# Access Compliance Report

### (Curb Ramps)

Intersection ID: 54324	Main Street: BELMONT_MANSION_DR	Cross Street: ROCKY_HILL_CASTLE_DR	Location:	N
ADA ID: D20A38E07E3D	Ramp Type: Perp	Initial Pass/Fail: Fail	Overall Compliance: No	Severity Score: 25

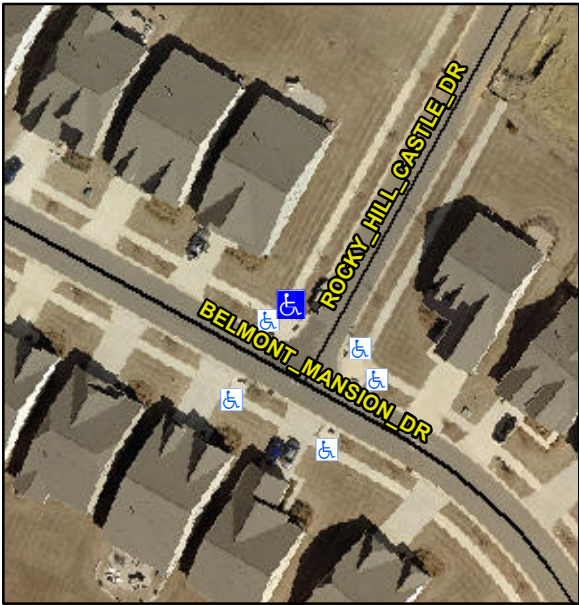
Codes/Mitigation Info/Possible Solution			Field Measurements/Component Compliance					
	Possible Solutions:		Compliance	Description	Data	Compliance	Description	Data
	Remove & Replace Entire Ramp.		N/A	Ramp Length (in)	100.0	Yes	Ramp Slope (%)	7.8
			Yes	Ramp Width (in)	48.0	No	Ramp XSlope (%)	10.3
			N/A	Flare Type LT	N/A	N/A	Flare Type RT	N/A
			N/A	Flare Slope LT (%)	N/A	N/A	Flare Slope RT (%)	N/A
			N/A	Flare Traversable LT?	N/A	N/A	Flare Traversable RT?	N/A
			N/A	Landing Length (in)	N/A	N/A	DWS Provided?	N/A
			N/A	Landing Width (in)	N/A	N/A	DWS Contrast?	N/A
			N/A	Landing Slope (%)	N/A	N/A	DWS Length (in)	N/A
			N/A	Landing X Slope (%)	N/A	N/A	DWS Full Width?	N/A
Surveyor Notes:	N/A		N/A	Landing Curb? (Y/N)	N/A	N/A	DWS Offset (in)	N/A
			N/A	Shared Landing?	N/A			
			N/A	Gutter Ponding?	N/A	N/A	Gutter Slope (%)	N/A
			N/A	Gutter Lip Ht (in)	1.5	N/A	Gutter X Slope (%)	N/A
			N/A	Painted X Walk1?	No	N/A	Painted X Walk2?	N/A

X Walk 1 Direction	To SE		X Walk 2 Direction	N/A
			N/A	X Walk 1 Width (in)	N/A	N/A	X Walk 2 Width (in)	N/A
				X Walk 1 Slope (%)	0.4		X Walk 2 Slope (%)	N/A
				X Walk 1 X Slope (%)	3.0		X Walk 2 X Slope (%)	N/A
			N/A	Ramp inside XWalk1?	N/A	N/A	Ramp inside XWalk2?	N/A
PROW/ADA:	Not Found, R304.5.3			Road Slope (%)	N/A	N/A	Clear Space?	N/A
				Road X Slope (%)	N/A	N/A	Clear Space to XWalk (in)	N/A
			N/A	Any Obstructions?	N/A	N/A	Storm Grate/Utility Hazard?	N/A
				Obstruction Type			Storm Grate/Utility Type	
					N/A			N/A
						Yes	Surface Condition? (G/P)	Good
	Total Cost:		\$	1850.00
